Addendum 65: Regulation No. 66

Revision 1 – Amendment 2

Uniform provisions concerning the approval of large passenger vehicles with regard to the strength of their superstructure

Annex I,

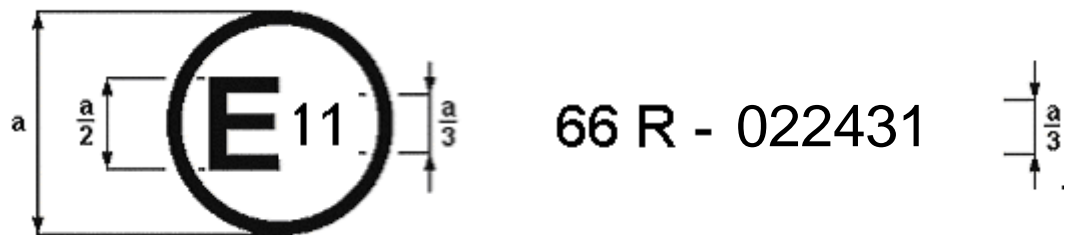
Item 3., amend to read (including the insertion of a new footnote 3):

“3. Vehicle category/class³: ...

³ As defined in Annex 7 to the Consolidated Resolution on the Construction of vehicles (R.E.3), (document TRANS/WP.29/78/Rev.1/Amend.2 as last amended by Amend.4)”
